Appl. No. : 09/938,428  
Filed : August 23, 2001

Figure 1B

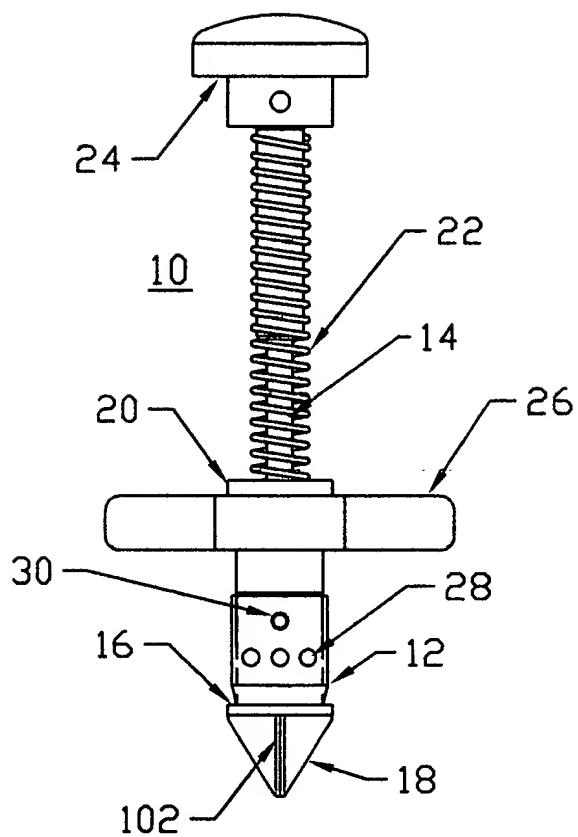
Figure 1B now depicts longitudinal ridges or edges **102** on the tapered tip. The longitudinal ridges **102** are supported in the originally filed specification. On page 12, lines 16 and 17, the specification states, "Longitudinal edges are optionally disposed on the conical surface of trocar or tip **18** to enhance tissue penetration". In addition, Claims 9, 10, and 11 of the originally filed application, state:

Accordingly, Applicants respectfully submit that no new matter is introduced by the proposed drawing change to Figure 1B.
